# Access Compliance Report

## Public Rights-of-Way

### (Curb Ramps)

Intersection ID: 10032174	Main Street: MORRIS_FIELD_DR	Cross Street: N/A	Location: S
ADA ID: 3FD7C662A543	Ramp Type: BlendTrans1	Initial Pass/Fail: Fail	Overall Compliance: No
		Severity Score: 10

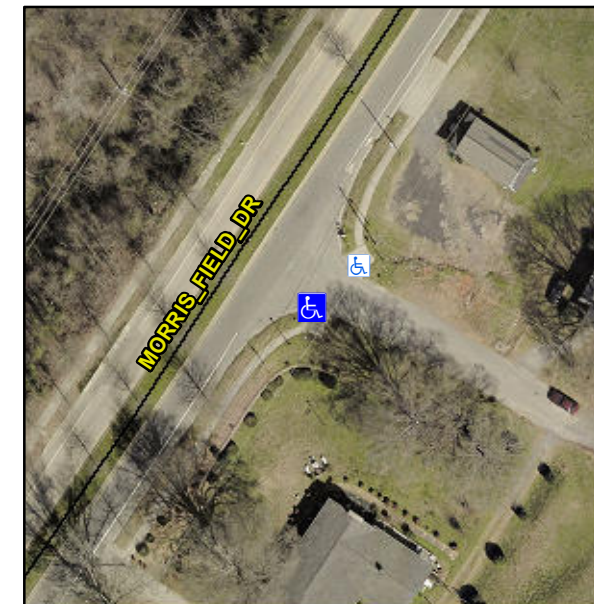
Surveyor Notes:

**MEDIAN ACROSS MORRIS FIELD DR**

PROW/ADA:

**Not Found, R304.5.1, R304.5.3**

Compliance	Description	Data	Compliance	Description	Data
N/A	Ramp Length (in)	72.0	Yes	BlendTrans Slope (%)	1.1
No	Ramp Width (in)	46.0	No	BlendTrans XSlope (%)	2.6
N/A	Flare Type LT	N/A	N/A	Flare Type RT	N/A
N/A	Flare Slope LT (%)	N/A	N/A	Flare Slope RT (%)	N/A
N/A	Flare Traversable LT?	N/A	N/A	Flare Traversable RT?	N/A
N/A	Landing Length (in)	N/A	N/A	DWS Provided?	N/A
N/A	Landing Width (in)	N/A	N/A	DWS Contrast?	N/A
N/A	Landing Slope (%)	N/A	N/A	DWS Length (in)	N/A
N/A	Landing X Slope (%)	N/A	N/A	DWS Full Width?	N/A
N/A	Landing Curb? (Y/N)	N/A	N/A	DWS Offset (in)	N/A
N/A	Shared Landing?	N/A			
N/A	Gutter Ponding?	N/A	N/A	Gutter Slope (%)	N/A
N/A	Gutter Lip Ht (in)	N/A	N/A	Gutter X Slope (%)	N/A
N/A	Painted X Walk1?	No	N/A	Painted X Walk2?	N/A
	X Walk 1 Direction	To NE		X Walk 2 Direction	N/A
	X Walk 1 Width (in)	N/A		X Walk 2 Width (in)	N/A
	X Walk 1 Slope (%)	3.0		X Walk 2 Slope (%)	N/A
	X Walk 1 X Slope (%)	1.6		X Walk 2 X Slope (%)	N/A

N/A	Ramp inside XWalk1?	N/A	N/A	Ramp inside XWalk2?	N/A
	Road Slope (%)	1.6		Clear Space?	N/A
	Road X Slope (%)	3.0	N/A	Clear Space to XWalk (in)	N/A
N/A	Any Obstructions?	N/A	N/A	Storm Grate/Utility Hazard?	N/A
	Obstruction Type			Storm Grate/Utility Type	
		N/A			N/A
			Yes	Surface Condition? (G/P)	Good
			No	Curb Slope (%)	12.3

Possible Solutions:

**Remove & Replace Curb Ramp With Two New Directional Ramps or Equivalent.**
